BELL SYSTEM PRACTICES
Station Installation and Maintenance

ADDENDUM C55.611
Issue 1, March, 1954
AT&T Co Standard

1A AND 1AA

TELEPHONE ANSWERING SETS

Fig. 15—IAA Belt Drive

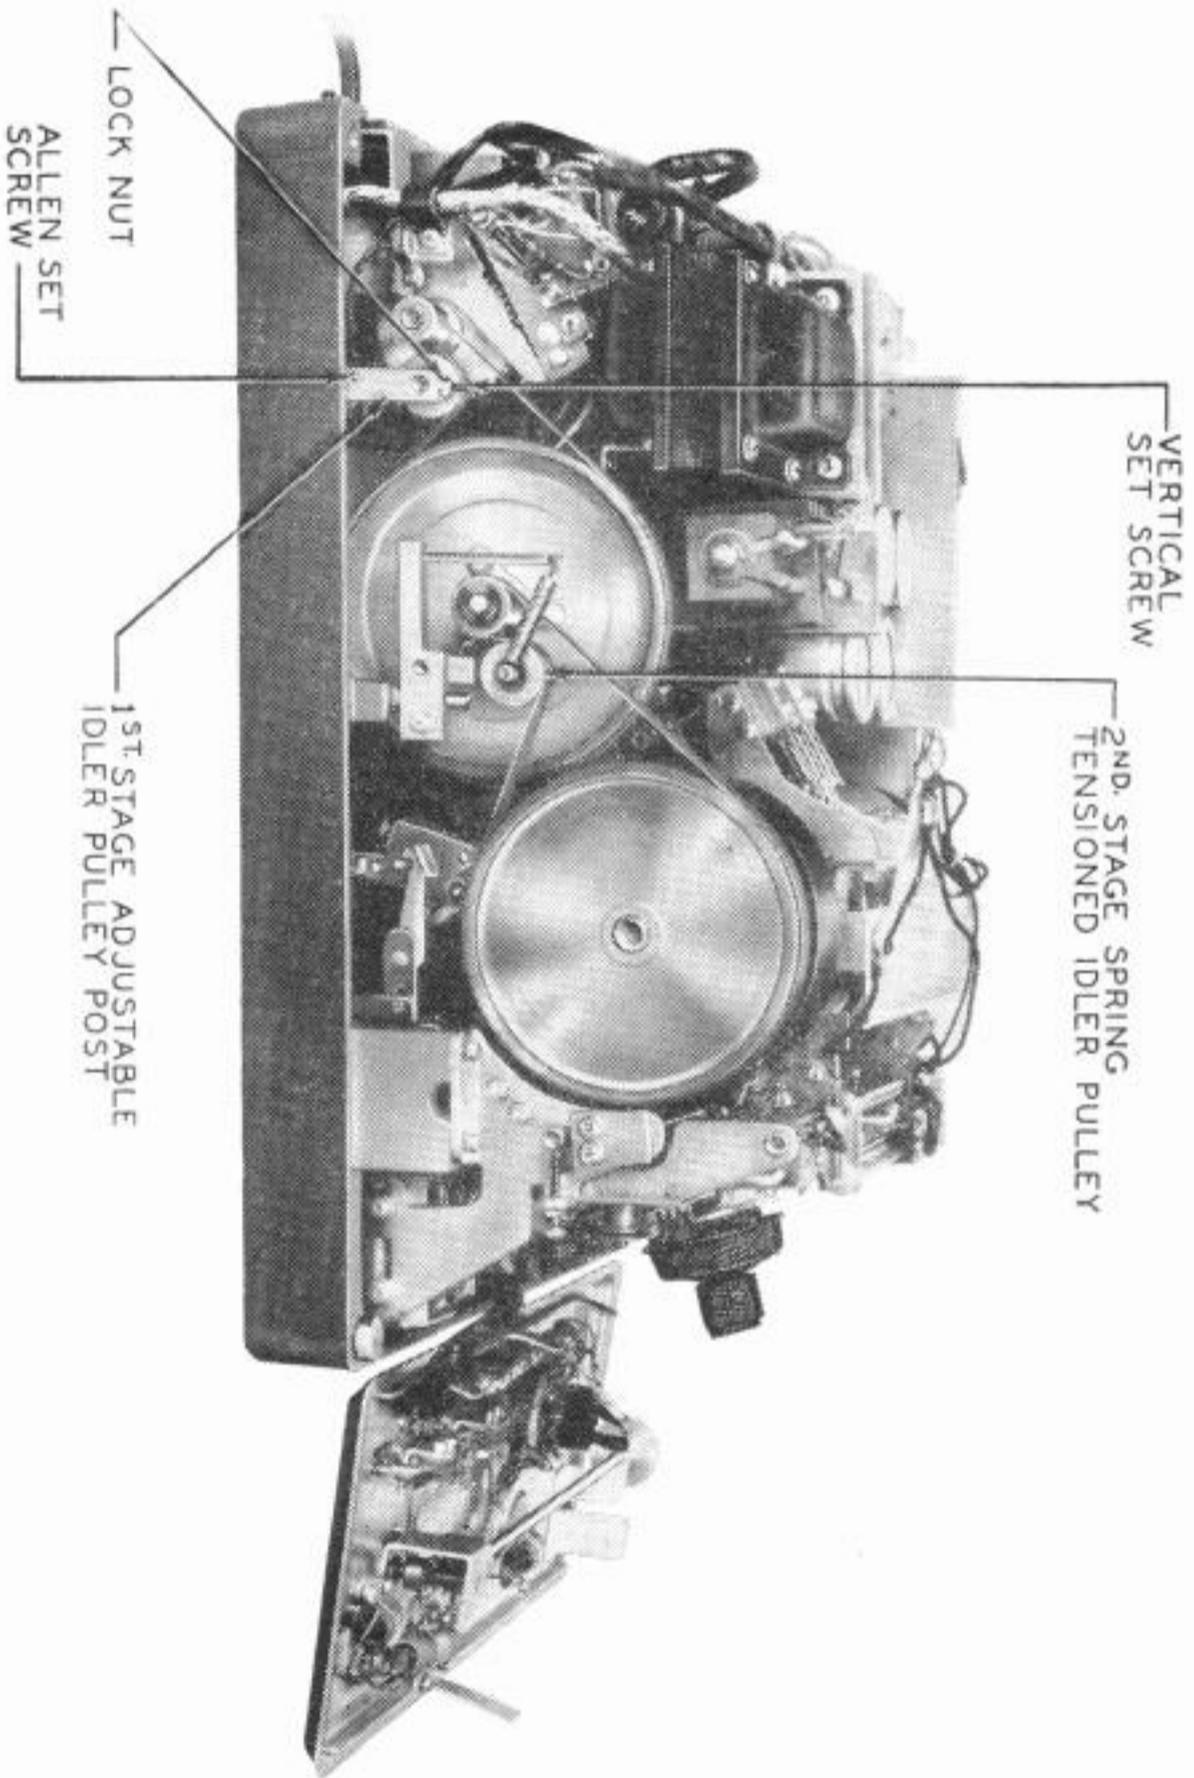
(a) 2.02—revised—added sentence

(b) Fig. 15—added

2.02 The recording drums are driven by a 4-pole, 1700 rpm, 115V, 60-cycle single-phase induction motor. On the motor shaft is mounted a 52-tooth gear which is the rotor of the tone generator. This gear forms a path of variable magnetic reluctance between two pole pieces connected by a permanent magnet and surrounded by a coil of wire. As the gear turns, the variation of magnetic flux induces an alternating voltage in the coil at a frequency of 1400 cycles. The main drum shaft is driven by a 2-stage belt pulley speed reduction. Each belt on 1A Sets is tensioned by an adjustable idler pulley. On 1AA Sets, the first

stage belt is tensioned by an adjustable idler pulley while the one in the second stage is tensioned by a spring-loaded idler pulley (see Fig. 15).

Fig. 16—Tube Retainer on 1AA Set

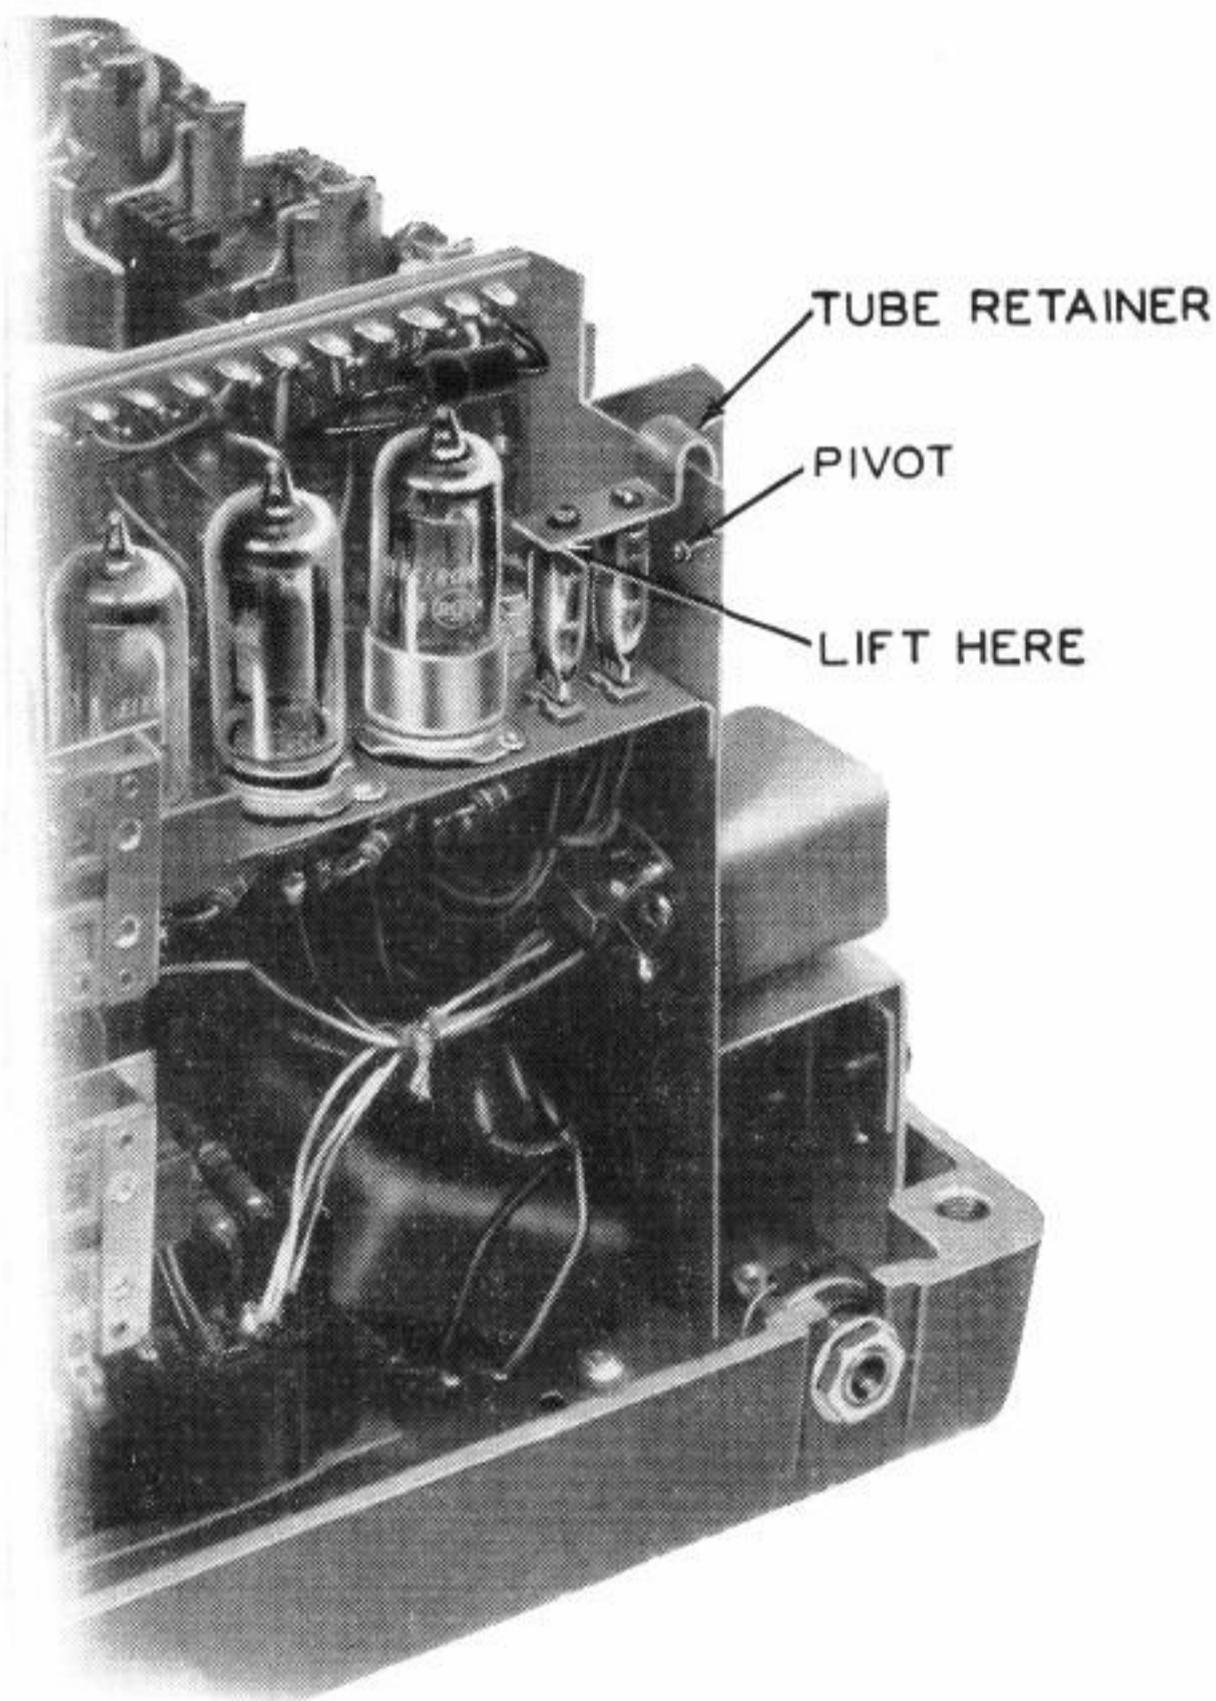
- (a) 5.02 (2)—added unnumbered paragraph
- (b) 5.10—revised
- (c) 5.13—added sentences and Table A
- (d) Fig. 16—added

5.02 (2) (After 5.02 (2) add the following unnumbered paragraph for 1AA Sets)

The 1AA Sets have a retainer holding these two tubes in place. When necessary to remove tubes, lift end of retainer just high enough to clear tops of tubes, then pull out and down at bend, pivoting retainer at rivet (see Fig. 16).

Fig. 17—1AA Telephone Answer Set Control Schematic

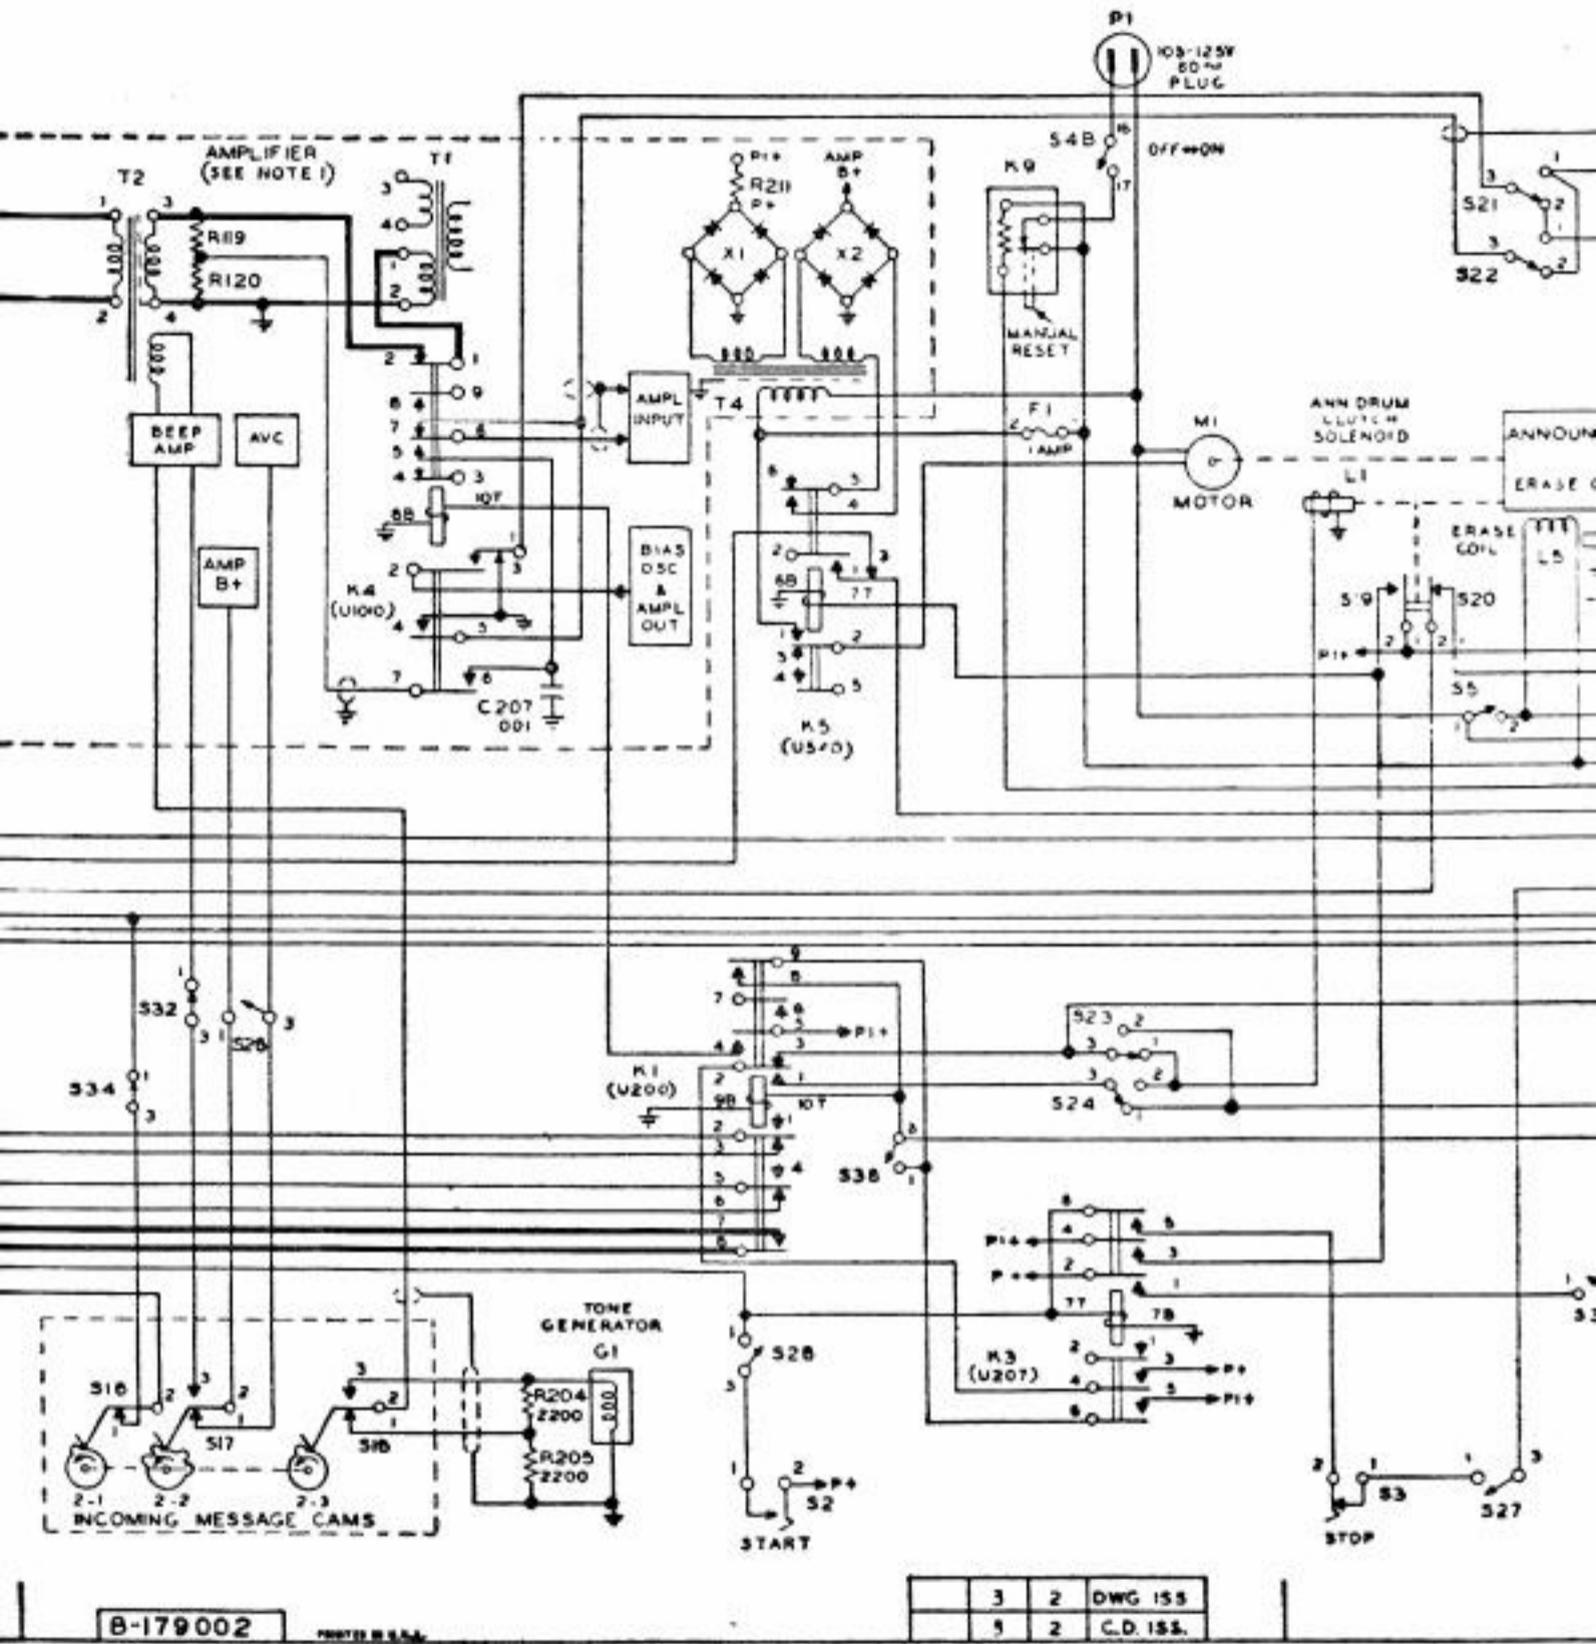
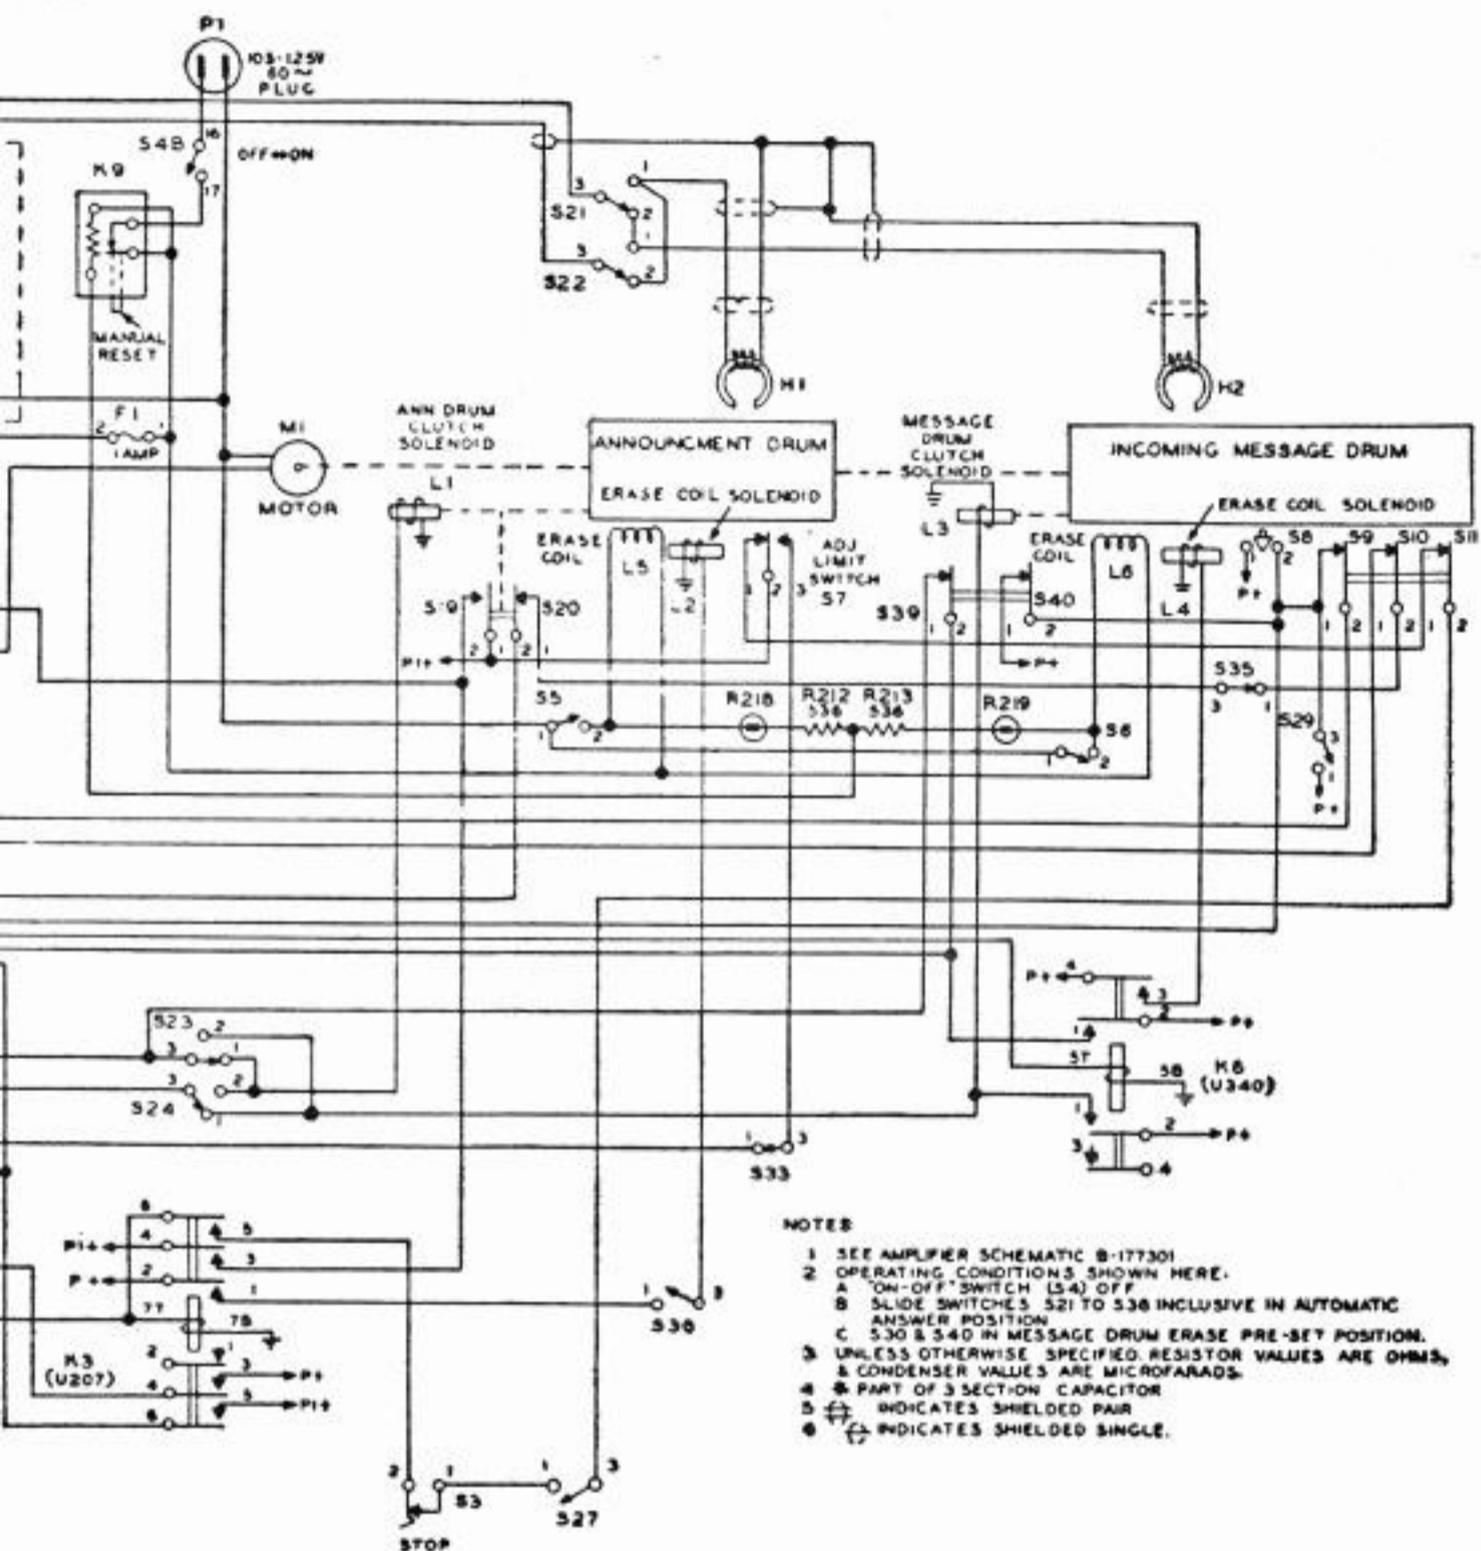
4. CIRCUIT DESCRIPTION (See Fig. 14 for 1A Sets, Fig. 17 for 1AA Sets)

- (a) Title—revised
- (b) 4.04—revised
- (c) 4.13—revised
- (d) 4.17—revised
- (e) 4.27—added unnumbered paragraphs
- (f) 4.32—revised
- (g) 4.33—revised
- (h) Fig. 17—added

4.27 (After 4.27 add the following unnumbered paragraphs for 1AA Sets)

Ringing current (Bridged Ringing—Low Impedance) from the R terminal passes through S4, C202, Thermistor R215, strap A-B, X4 varistor (which rectifies current that actuates winding 6T and 4B of K2) S20, S35, S10 to G.

Ringing current (Bridged Ringing—High Impedance) from L2Y terminal in 531C Subscriber Set flows through vacuum tube, K to ground operating relay in 531C. 48V P+ from E terminal in 1AA passes through closed contacts of relay in 531C, B terminal of 1AA, 6T and 4B of K2, S20, S35, S10, G terminal, strap G-F to chassis ground, operating K2.
